97-615

Message: Permit 97-615
Re: Sewage System for Forsythe, Barrere

PLOT PLAN DRAWN TO SCALE (to be completed by the Applicant/Contractor)

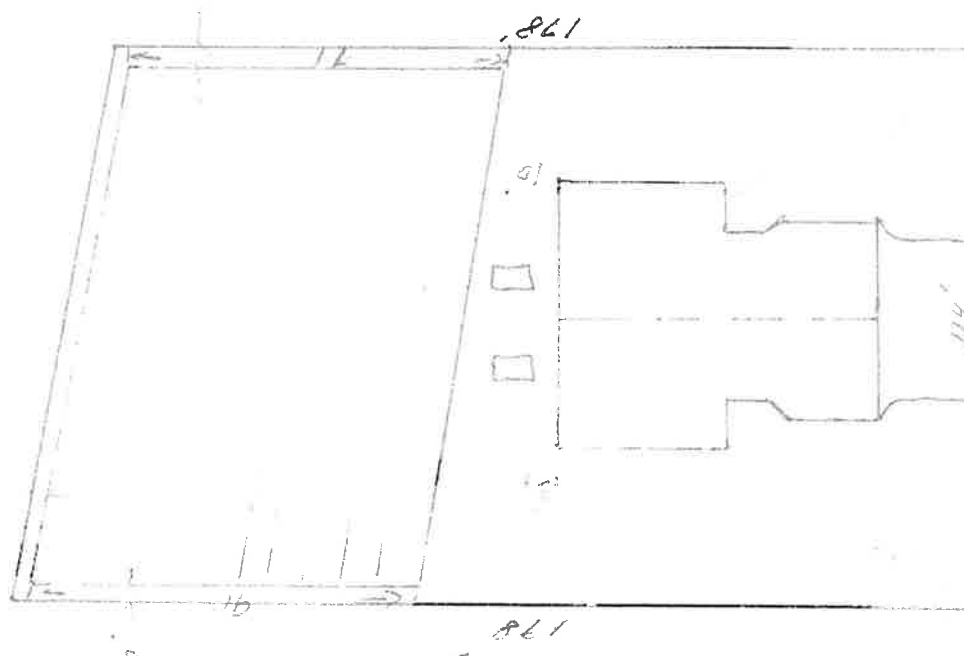
Conditions of Permit: ① Sewage disposal system to be constructed in accordance with regulations as outlined in plate 1978-1+2
② Absorption field must be located to provide area for back-up secure field area. ③ Perforated pipe must be laid to a maximum depth of 17 inches (43 cm) below finished grade with a maximum slope of 4 inches per 100 ft (10 cm/30 m)

Yes, separate tanks & systems are do-able.
Clare has suggested 4 x 60' runs, squeezed
against outside property lines (10 ft setback)
Shas & will leave sufficient area
in centre for replacement systems if
needed in future.
